PLANNING AND ACCESS COMMITTEE
MEETING 26 August 2019

SUBMITTED BY:	Director of Rural Development and Planning
APPLICATION REF:	2019/0098/DET
APPLICANT:	Lovell Homes on behalf of Rural Stirling Housing Association
LOCATION:	Land At Claish Farm, Callander, Stirling, FK17 8JJ

PROPOSAL:	Erection of 50 no. dwellinghouses with associated infrastructure, landscaping and engineering works
NATIONAL PARK WARD:	Ward 3: Callander
COMMUNITY COUNCIL AREA:	Callander Community Council
CASE OFFICER:	Name: Caroline Strugnell Tel: 01389 722148 E-mail: caroline.strugnell@lochlomond-trossachs.org

Figure 9: Existing footpath at MacLaren Leisure Centre on the A81 north of the application site (extract from Google Street View).

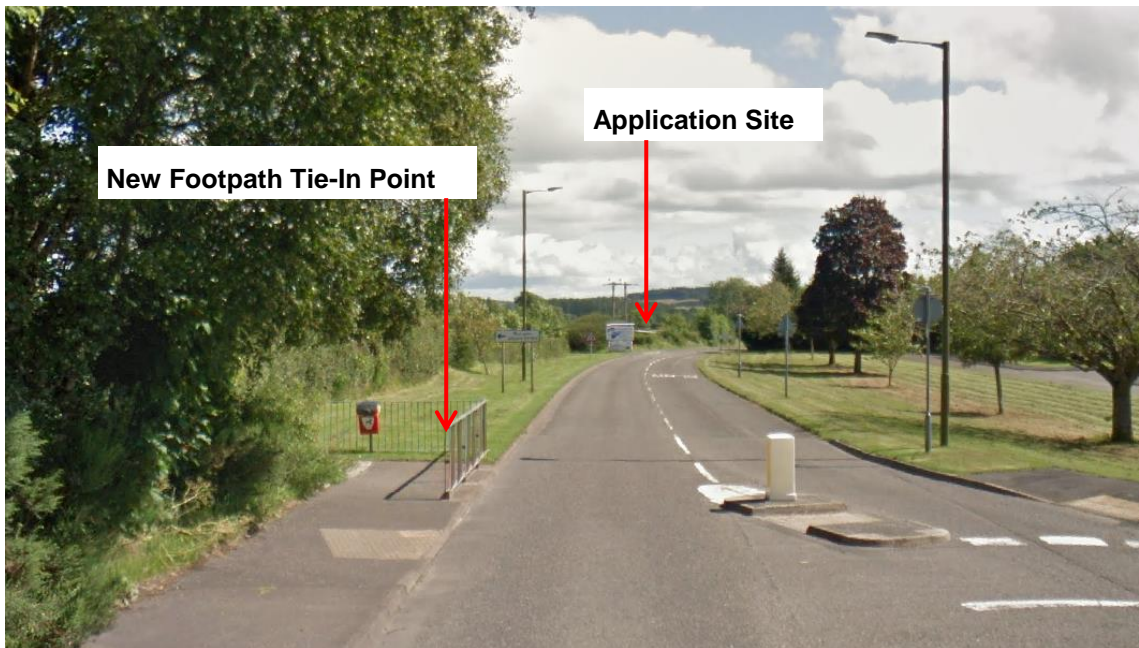
at the Leisure Centre entrance (Figure 9). From here onward connections are available to McLaren High School, Callander Primary School and the town centre. Access to the Core Path network and National Cycle Network 7 (Sunderland – Inverness) to the north of the application site would also be possible via this new link.

Figure 14: Applicant’s indicative layout for MU2 drawn up pursuant to the *Callander South Masterplan Framework Planning Guidance* requirement.

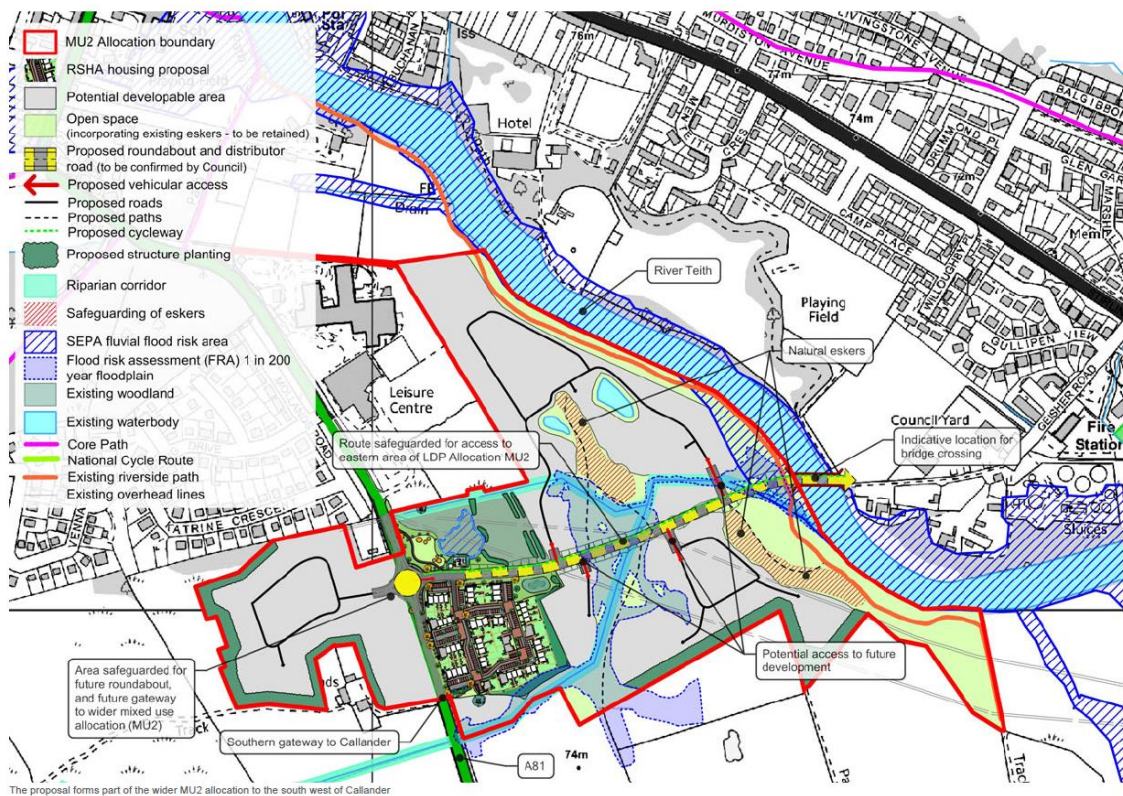
- 8.8. The indicative layout broadly reflects the Framework Guidance proposals (Figure 12) and takes these a step further in adding an additional layer of detail. This includes areas of flood risk and landscape features, details of the roundabout access from the A81 and alignment of the future link road across the River Teith. It incorporates the first phase of development (the application site) which corresponds to the Framework Guidance allocation for mixed-use development including housing for this part of the MU2 site. It also shows the broad areas which might have potential to be developed in future (in grey) and areas that would likely remain undeveloped which could form green corridors and linkages, and open spaces including a Riverside Park.

- 8.30. In summary, whilst the submitted indicative layout for the MU2 allocation is lacking in detail for the wider site, the application proposal accords with the Framework Guidance land use allocation and satisfies the key design principles in so far as these relate to the application site. The application proposal also safeguards the ability to deliver strategic road infrastructure to provide access to later phases of development and to ensure strategic transport objectives for Callander are not prejudiced.
- 8.31. The remaining, more general Framework Guidance considerations (e to l above) are now assessed along with compliance with the relevant policies of the Local Development Plan.

Figure 15: Pedestrian routes. Extract from Design and Access Statement

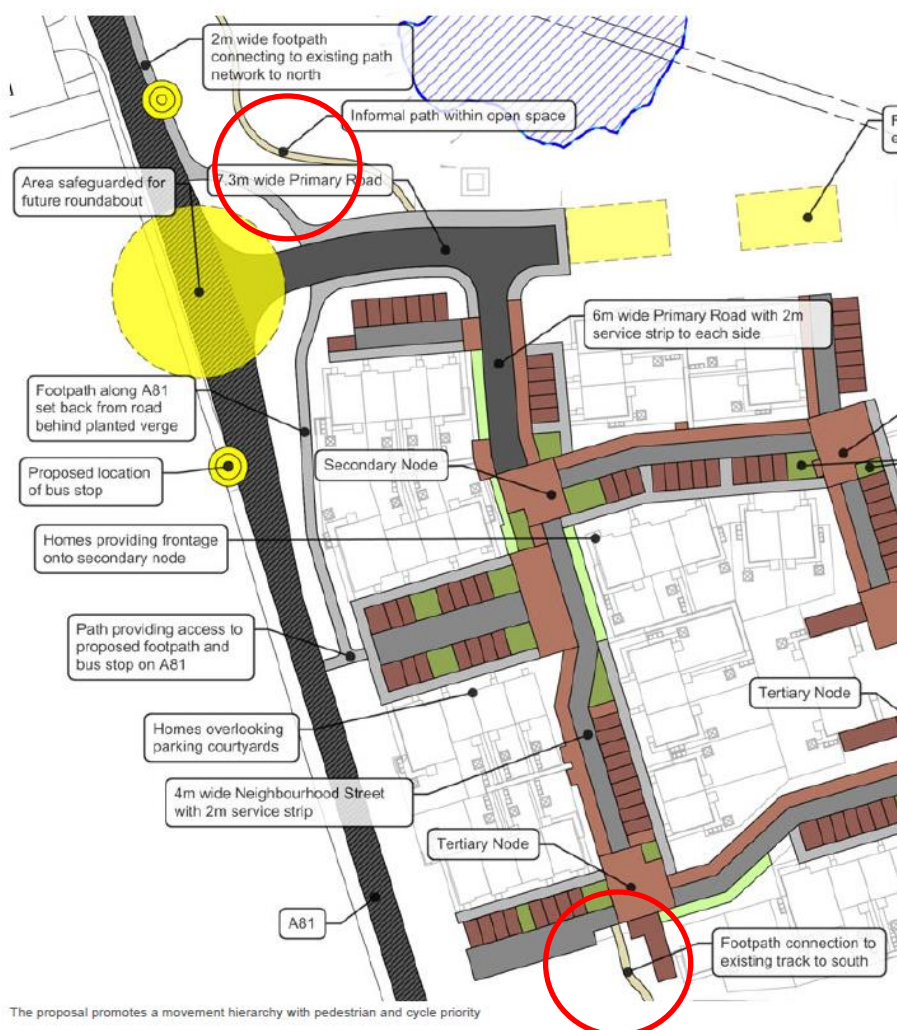
- 8.21. The Community Council response requests that the path connection be made separate from the road. However the applicant has informed that this is not possible due to land ownership constraints and the location of utility services. The speed limit at this section of road is 30mph and the arrangement of the path adjacent to the road is the same as the existing path to the north of the leisure centre entrance. There would be no safety implications arising from the proposed arrangement.

- 8.22. A separate informal path is proposed within the new recreation area which offers an alternative green route set away from the roundabout junction (Figure 15). The proposal also includes an informal footpath connection from the parking court in the south western corner through to the existing agricultural track at the southern boundary (Figure 15). This track has the potential to be upgraded in the future to provide green/recreational connections to the remainder of the MU2 allocation and east to the River Teith as part of future phases of development. Further pedestrian and cycle opportunities would be possible in association with the eastward continuation of the link road.

Figure 23: Extract from submitted *Indicative Landscape Framework 17022-LAFW-P001-A* showing integration of the application site with indicative landscape proposals for the wider South Callander area.

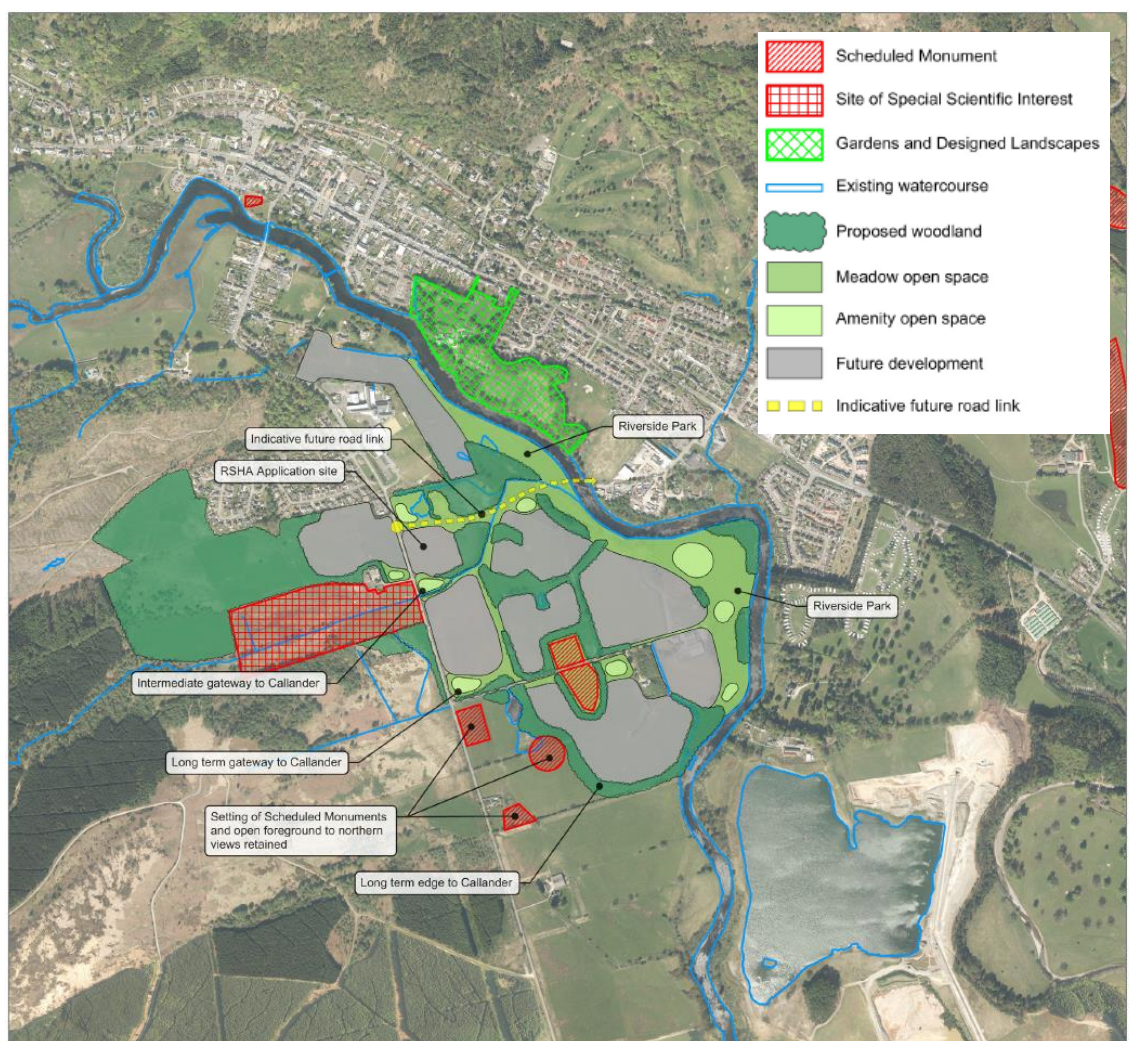
- 8.58. It has also to be recognised that this development would be a first phase in the wider planned expansion of Callander to the immediate west and east (and in the longer term, to the south) which would help balance and integrate the development with the surroundings in future years. To demonstrate this, the applicant has submitted an Indicative Landscape Framework (Figure 23). This shows woodland planting to the immediate east of the development and further enhancement and strengthening of the character of the Mollands Burn to the south of the development with opportunity for recreational links extending eastwards into the wider MU2 allocation. This shows how the application proposal could ultimately be integrated within a wider green network and how it might relate to the wider development in the South Callander area in the longer term. The proposed woodland planting could be implemented either in advance or would be secured in association with future development phases.

- 8.59. The visual impacts of the development, particularly on the southern approach, would be most acute in Year 1 following development prior to the establishment of the woodland edge planting (Figure 20). For this reason a revised *Landscape General Arrangement Plan (17022-LAGA-P002-1)* was requested incorporating a greater number of heavy standard feature trees in the woodland edge on the southern and western boundaries. This would provide an enhanced level of screening in the earlier years and goes some way to addressing the landscape and visual concerns. Further, the applicant has agreed to reconsider the details of the 1800 high fence along the eastern and southern boundaries to reduce the prominence of the development boundary in the landscape when viewed from the southern approach. A condition is recommended for revised details to be provided.
